Stephen L. Smith  
Engineering Vice President

September 29, 2021  
ET 21-0010

Subject: Docket No. 50-482: License Amendment Request – Revision to Technical Specification 3.3.2, “Engineered Safety Feature Actuation System (ESFAS) Instrumentation”

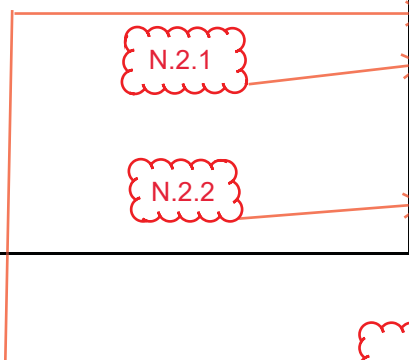
M. One channel inoperable.	M.1 Place channel in trip.  <u>AND</u> M.2 Restore channel to OPERABLE status.	1 hour   During performance of next COT
N. One train inoperable.	<p style="text-align: center;">-----NOTE-----                      One train may be bypassed for up to 2 hours for surveillance testing provided the other train is OPERABLE.                      -----</p> N.1 Be in MODE 3. <u>AND</u> N.2 Be in MODE 4.	<div style="text-align: right;"> <span style="border: 1px solid red; border-radius: 50%; padding: 2px;">30</span>  <del>6</del> hours                 </div> <div style="text-align: right;"> <span style="border: 1px solid red; border-radius: 50%; padding: 2px;">36</span>  <del>12</del> hours                 </div>

N.1 Restore train to OPERABLE status. 24 hours
